Attention Director
Application Number: SSI 7485

Infrastructure Projects, Planning
Services,
Department of Planning and
Environment
GPO Box 39, Sydney, NSW, 2001
Application Name:
WestConnex M4-M5 Link

I submit my objection to the WestConnex M4-M5 Link proposals for the reasons stated below, and request the Minister reject the application entirely, and cause the proponents to reissue an EIS that is based on a fully researched, developed, and budgeted concept design, and require the proponents to prepare a new business case against that design.

The EIS states in 6.5.8 Darley Road civil and tunnel site (C4) that:

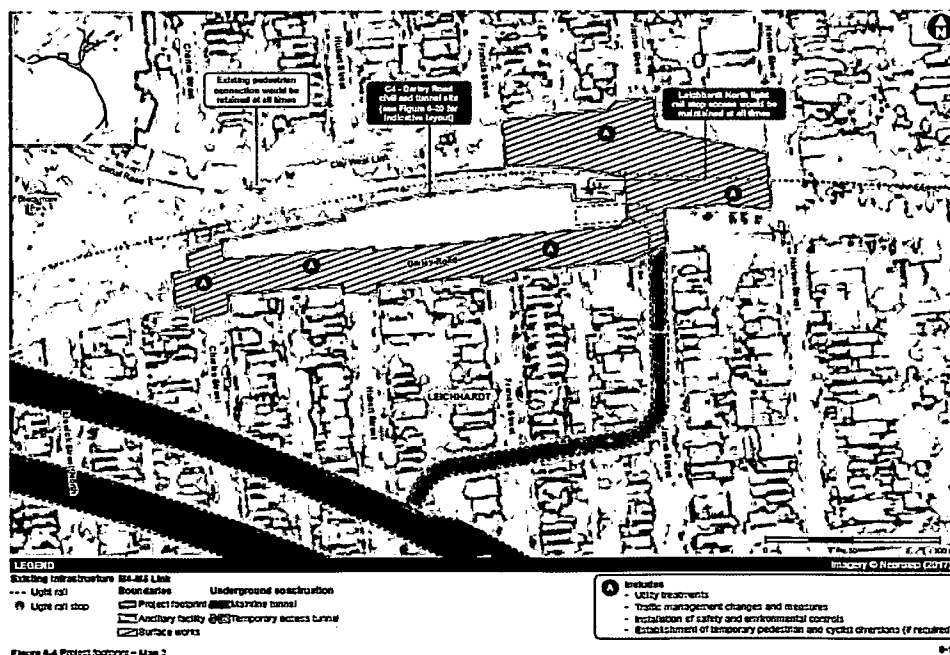
- I **object** to the EIS because it fails to describe the temporary changes to Darley Road, Leichhardt to enable access to and from the ancillary facility that would likely be required in relation to the Darley Rd site and instead allows for the final plan to be decided by the contractor.

It is not clear how continued access, pedestrian and cyclist movement will be preserved and I am concerned that the impacts have not been correctly identified and assessed by the proponent.

Cumulative impacts of aircraft noise and construction noise

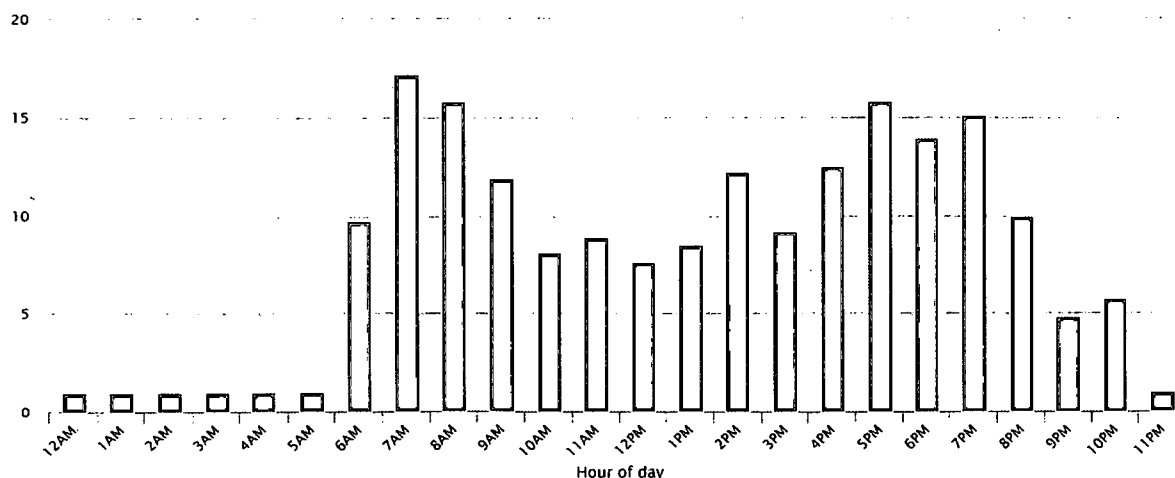
- I object** to the EIS because the proponent has failed to take account of the cumulative impact of its proposed Darley Road, Leichhardt civil and tunnel site operations and the aircraft noise which the residents near the site already endure.

The attached extract from Webtrak shows that Darley Road, Leichhardt and adjacent streets are directly under the flight path. Airservices Australia reports that in April to June 2017 the number of average daily noise events over 70 dBA. In Leichhardt this is an average of 16- 17 per hour over the peak morning period and 16 per hour in the early evening peak period.

Cumulative impacts of aircraft noise and construction noise

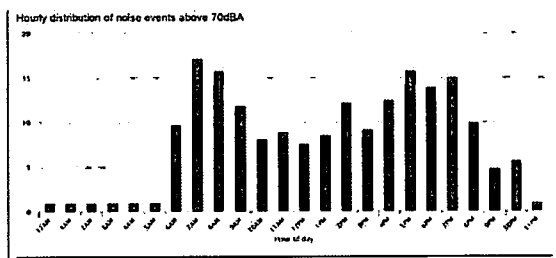
- I object** to the EIS because the proponent has failed to take account of the cumulative impact of its proposed Darley Road, Leichhardt civil and tunnel site operations and the aircraft noise which the residents near the site already endure.

The EIS states in 6.5.8 Darley Road civil and tunnel site (C4) that:

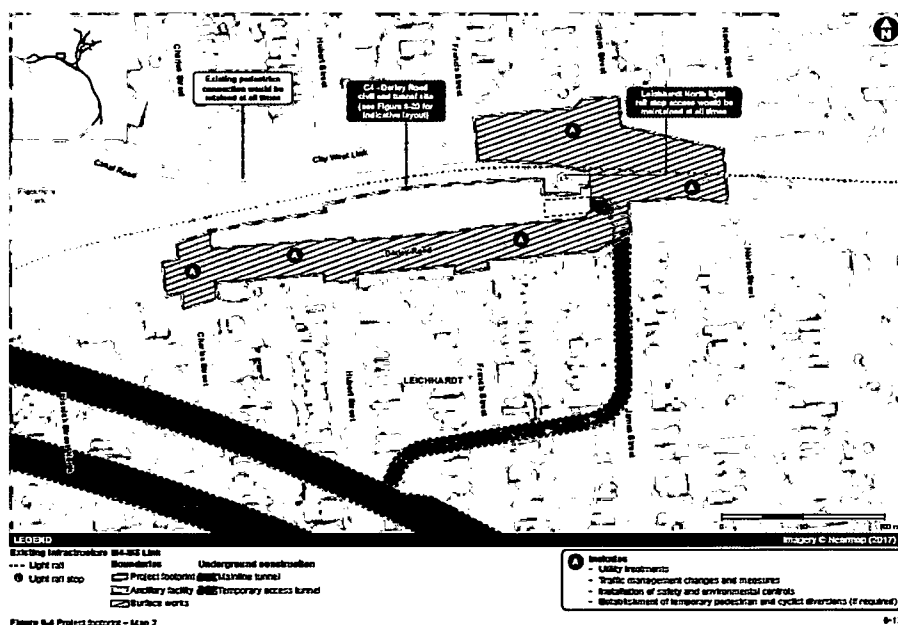
1. I object to the EIS because it fails to describe the temporary changes to Darley Road, Leichhardt to enable access to and from the ancillary facility that would likely be required in relation to the Darley Rd site and instead allows for the final plan to be decided by the contractor.

It is not clear how continued access, pedestrian and cyclist movement will be preserved and I am concerned that the impacts have not been correctly identified and assessed by the proponent.
